Contract for Gulf Shores Pavilion Turtle Lighting Retrofits

(Volkert Proj. No. 736101 Task 099)

SUBJECT: ADDENDUM NO. 2

NOTES, LEGEND, AND ABBREVIATIONS

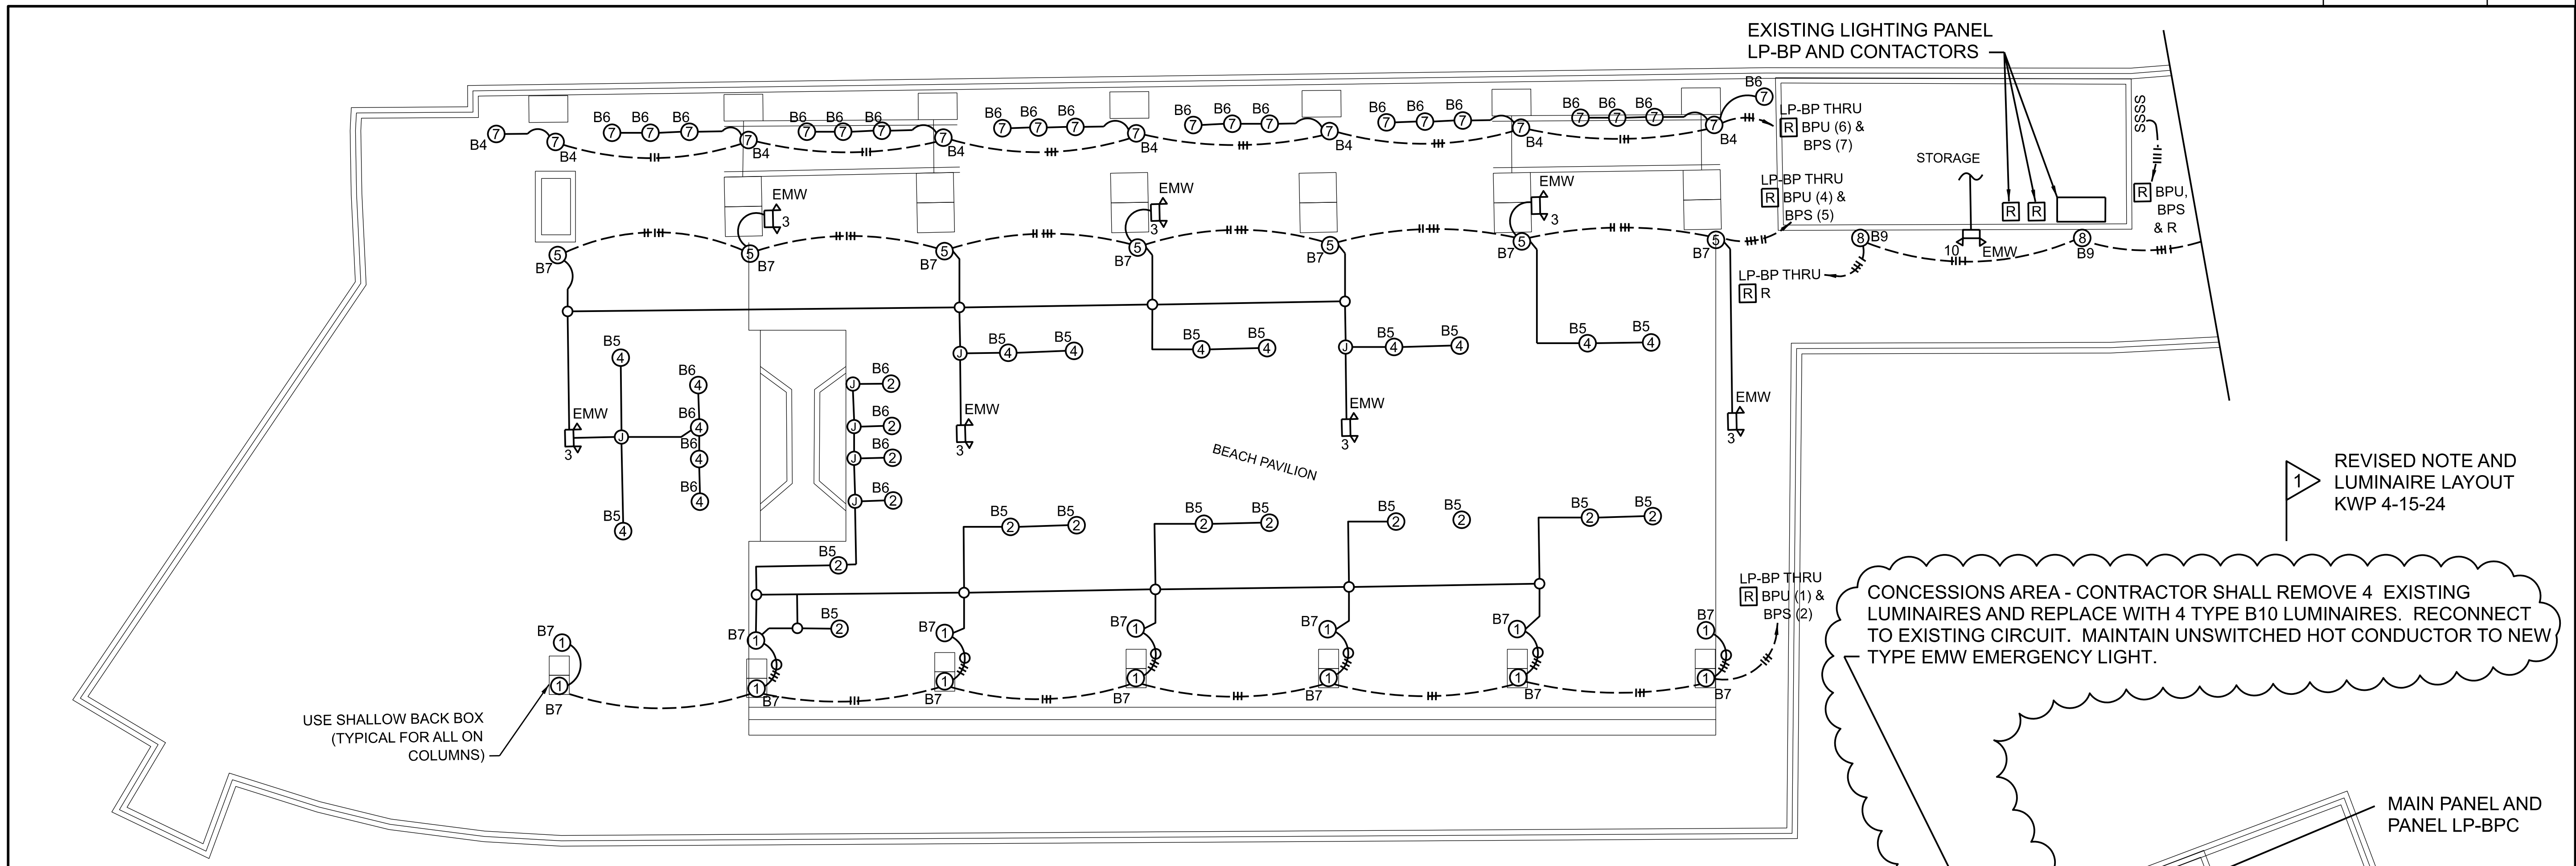
- (1) Luminaire Types B6, B10, and EXR3 as shown on the plans have been replaced with new products. The luminaire schedule has been updated to reflect the new products and quantities.
- (2) Plan Sheet 2 and Plan Sheet 3 have been revised and are included in this addendum with the changes clouded and flagged.
- (3) Sealed bids will need to be delivered to State Parks HQ at 64 North Union Street, Suite 538, Montgomery, AL 36130 until May 2, 2024, at 2:00pm Central time. Bids will be opened on May 3, 2024, at 2:00pm in the Director's conference room. Bidders will receive a virtual meeting invite for the bid opening as a courtesy.

1  REVISED LUMINAIRE SCHEDULE KWP 4-15-24
